Subject: Burnt Jacket Holdings I, LLC  
Beaver Cove Access Road (STI # 250115)  
LUPC Stormwater Review (Application #: RP 3313)

On behalf of Burnt Jacket Holdings I, LLC, Sevee & Maher Engineers, Inc. (SME) is pleased to submit this letter in response to the Stormwater Review comments by Sebago Technics dated March 4, 2025. The revised materials are intended to provide materials and address items that were of concern to the reviewer.

FIGURE 1  
STATION 13+00 TURNAROUND GRADING  
BEACONSFIELD FARM PROJECT  
ACCESS ROAD  
BEAVER COVE, MAINE

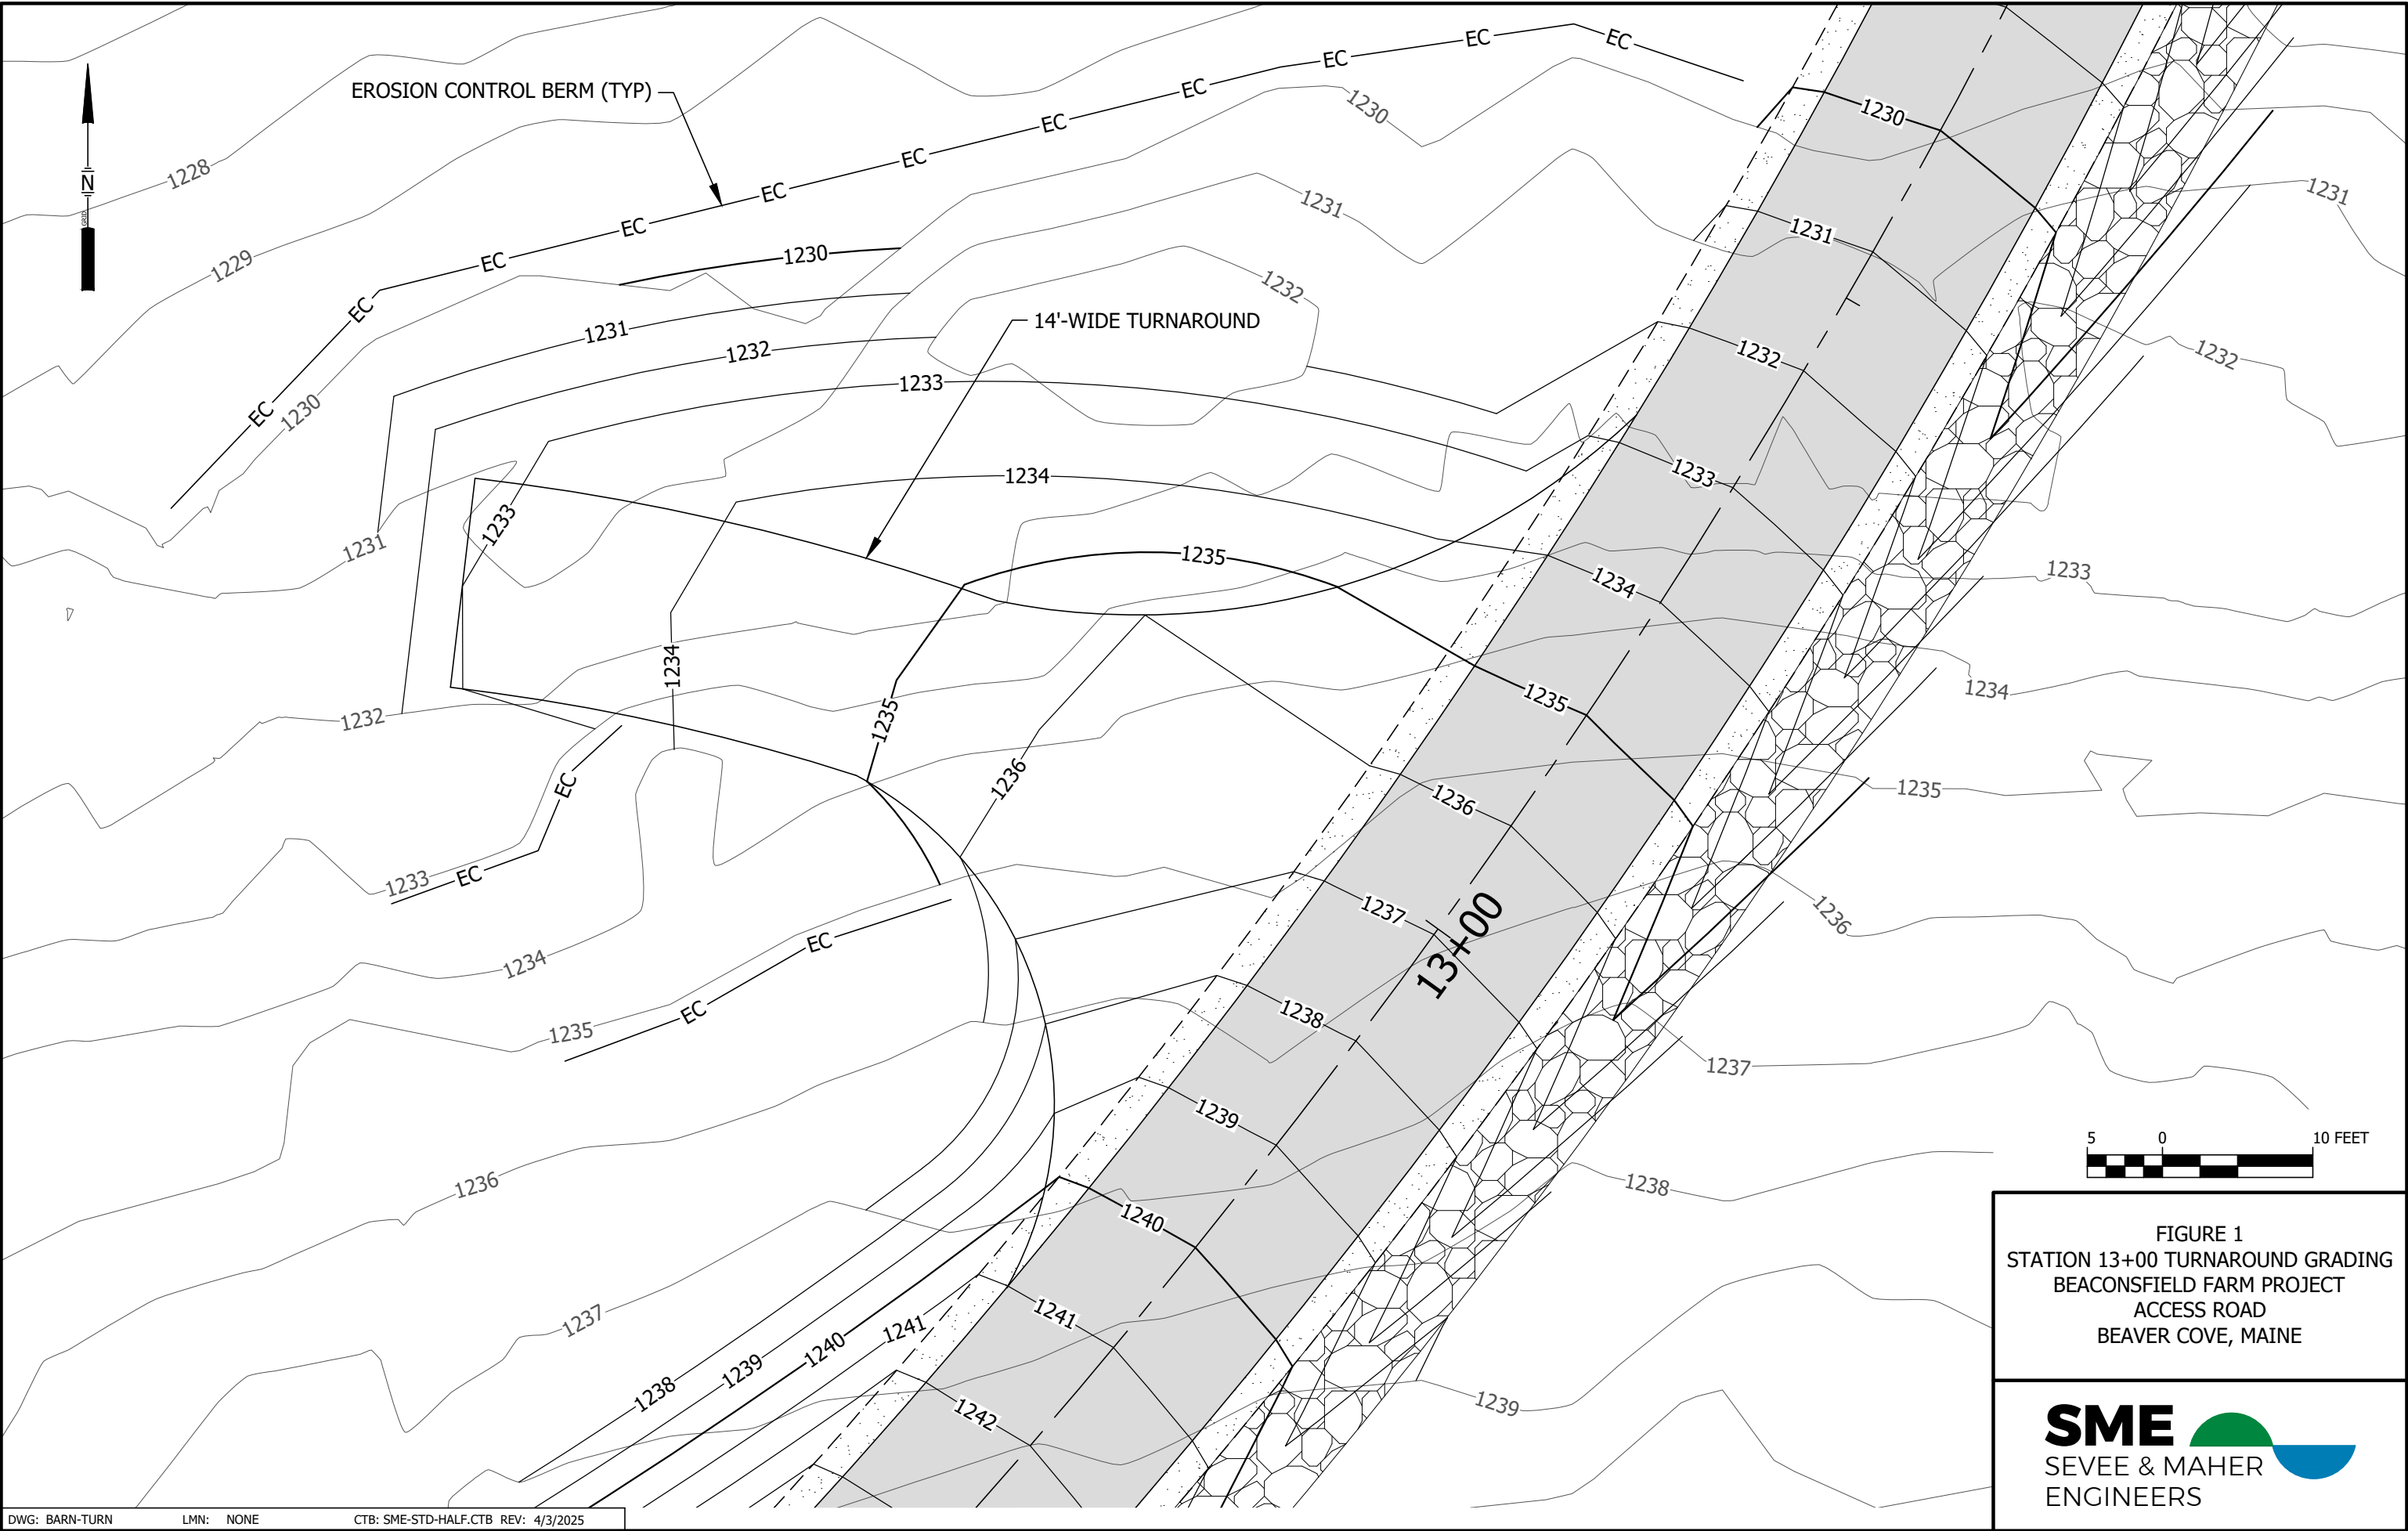
- 3. Plan Sheets C-201 and C-203 should be revised to show the design elements associated with the proposed turnaround locations such that they may be constructed in a way for use of the determined design emergency vehicle. Limits of disturbance including grading should also be shown and the erosion control devices extended to cover such limits.**

SME Response: The proposed turnaround at Station 13+00 will be updated to show grading and additional erosion control. This turnaround is an access to a future land management use which will be constructed as part of the driveway project and can be used as a turnaround for emergency vehicles. Figures 1 and 2 are included in Attachment 2 and show the turnaround location, grading, erosion control and traffic movements of an E'One fire truck. The proposed

FIGURE 3  
EMERGENCY VEHICLE ACCESS  
BEACONSFIELD FARM PROJECT  
ACCESS ROAD  
BEAVER COVE, MAINE

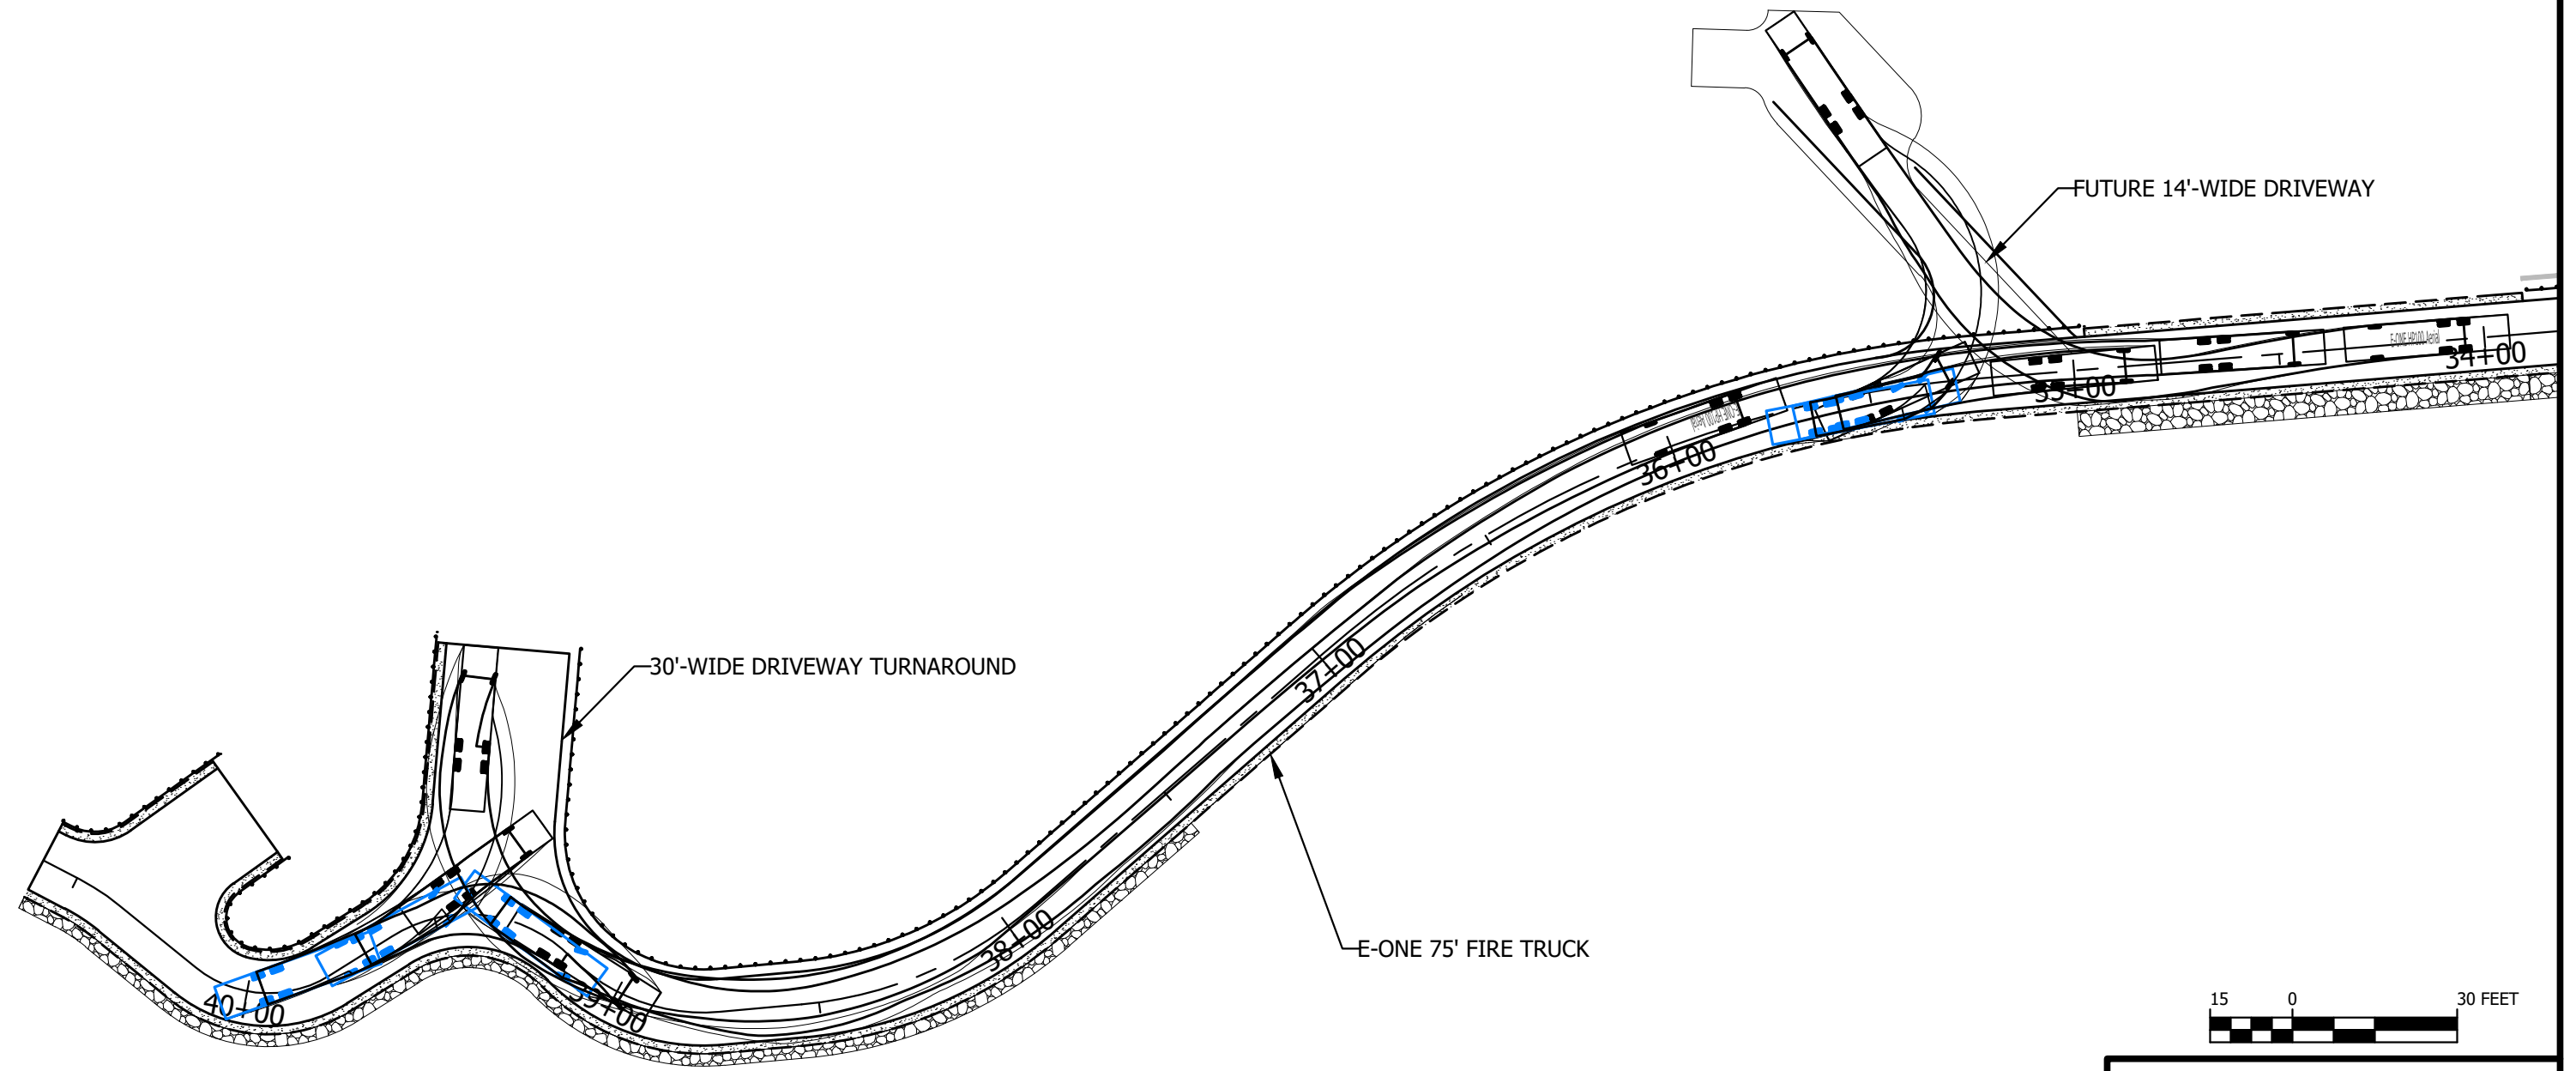
7. **The plan views on the plan and profile sheets should more clearly label the centerline horizontal curvature. In particular, the curves at the end of the road would seem to make it difficult for the selected design vehicle to maneuver.**

SME Response: Line and curve labels will be added to the plan view on Drawings C-200 through C-203. As noted in response #3 above, an AutoTurn analysis was performed with an E'One fire truck and all curves are sized for safe traffic movements. See the figures included in Attachment 2.
